Access Compliance Report

Public Rights-of-Way

Intersection ID: 14585	Main Street: RUBINE_ST	Cross Street: W_TYVOLA_RD	Location: S
ADA ID: 5F99DB827394	Ramp Type: Perp	Initial Pass/Fail: Fail	Overall Compliance: No
		Severity Score: 12.5

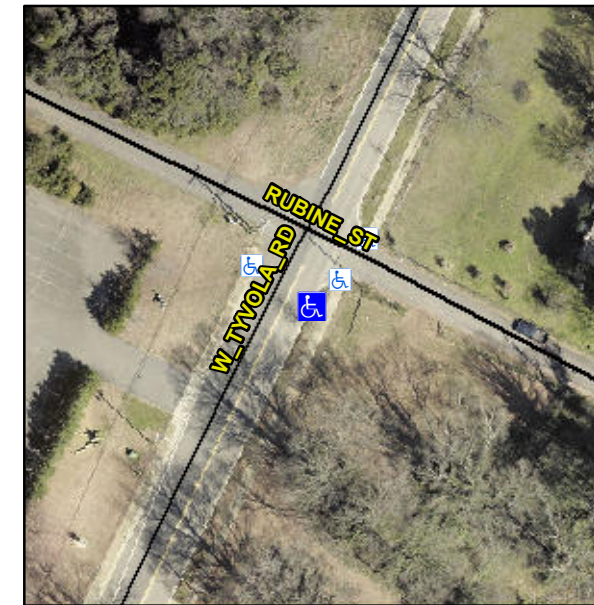
Not Found, R304.2.2

Compliance	Description	Data	Compliance	Description	Data
N/A	Ramp Length (in)	62.0	No	Ramp Slope (%)	9.4
Yes	Ramp Width (in)	70.0	Yes	Ramp XSlope (%)	0.6
N/A	Flare Type LT	N/A	N/A	Flare Type RT	N/A
N/A	Flare Slope LT (%)	N/A	N/A	Flare Slope RT (%)	N/A
N/A	Flare Traversable LT?	N/A	N/A	Flare Traversable RT?	N/A
N/A	Landing Length (in)	N/A	N/A	DWS Provided?	N/A
N/A	Landing Width (in)	N/A	N/A	DWS Contrast?	N/A
N/A	Landing Slope (%)	N/A	N/A	DWS Length (in)	N/A
N/A	Landing X Slope (%)	N/A	N/A	DWS Full Width?	N/A
N/A	Landing Curb? (Y/N)	N/A	N/A	DWS Offset (in)	N/A
N/A	Shared Landing?	N/A			
N/A	Gutter Ponding?	N/A	N/A	Gutter Slope (%)	N/A
N/A	Gutter Lip Ht (in)	N/A	N/A	Gutter X Slope (%)	N/A
N/A	Painted X Walk1?	No	N/A	Painted X Walk2?	N/A
	X Walk 1 Direction	To W		X Walk 2 Direction	N/A
N/A	X Walk 1 Width (in)	N/A	N/A	X Walk 2 Width (in)	N/A
	X Walk 1 Slope (%)	1.9		X Walk 2 Slope (%)	N/A
	X Walk 1 X Slope (%)	0.5		X Walk 2 X Slope (%)	N/A

Remove & Replace Entire Ramp.
